ORIGINATION FORM

Proposed Revisions to a Standard Plans Index

Index Number: 653-001

Index Title: Pedestrian Control Signal Installation Details

LAST REVISION 11/01/20	REVISION	DESCRIPTION:	 FY 2023-24 STANDARD PLANS	PEDESTRIAN CONTROL SIGNAL INSTALLATION DETAILS	INDEX 653-001	SHEET 1 of 1
------------------------------	----------	--------------	--	---	-------------------------	------------------------

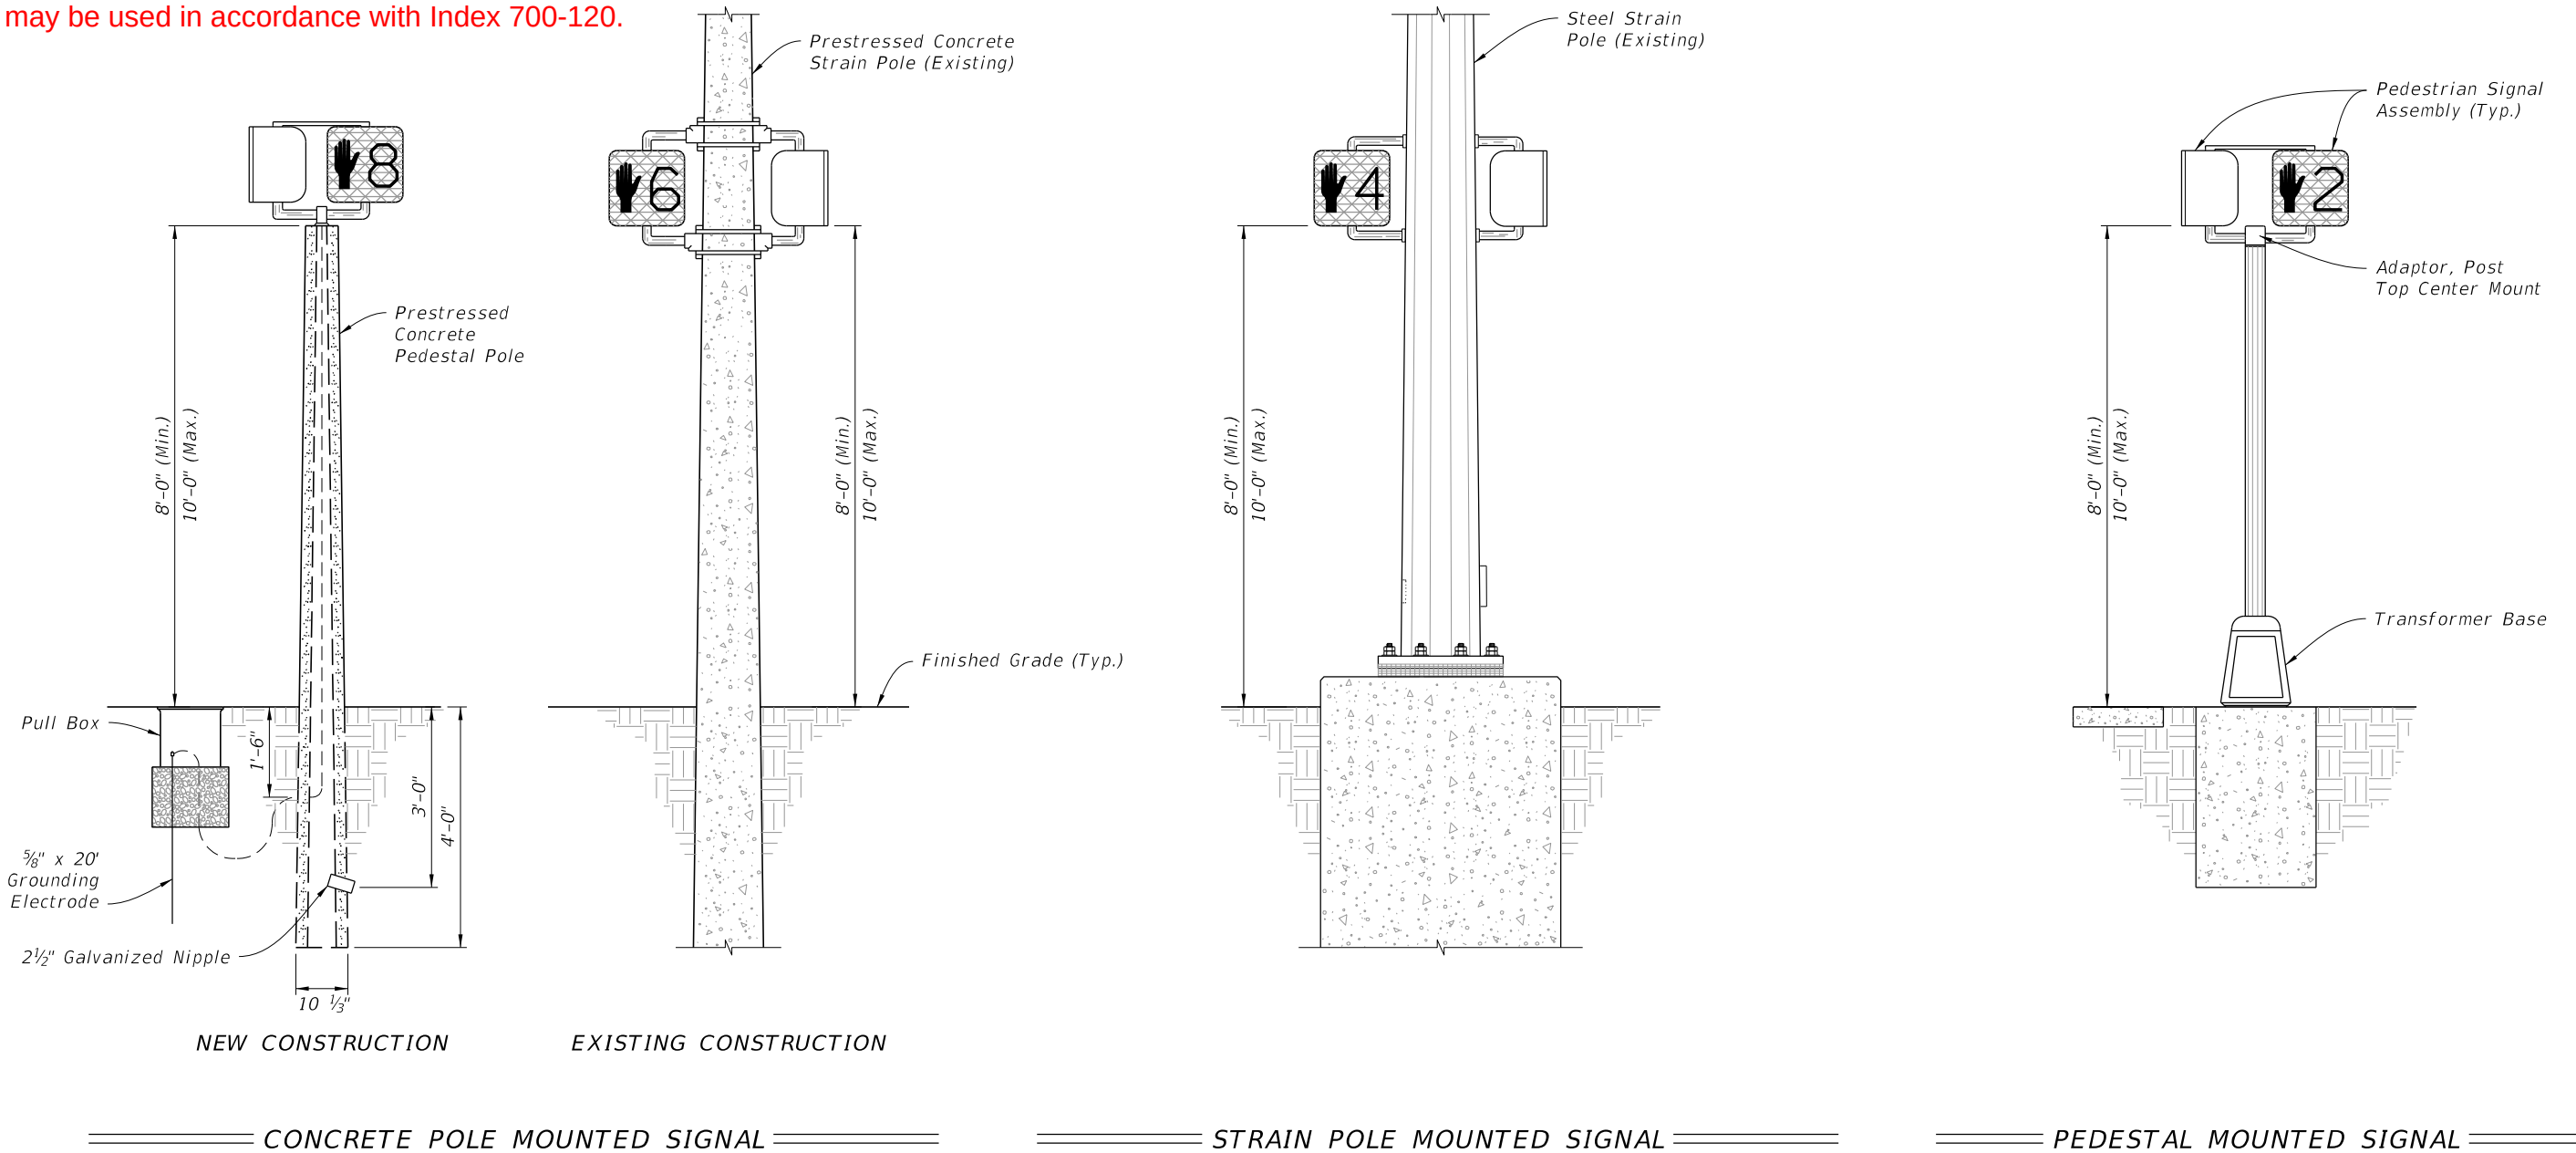
Added Note 8, "In lieu of footing design shown, a Spread Footing may be used in accordance with index 700-120."

Note 8 was added because of new spread footing design option in Standard Plans Index 700-120.

8. In lieu of footing design shown, a Spread Footing may be used in accordance with Index 700-120.
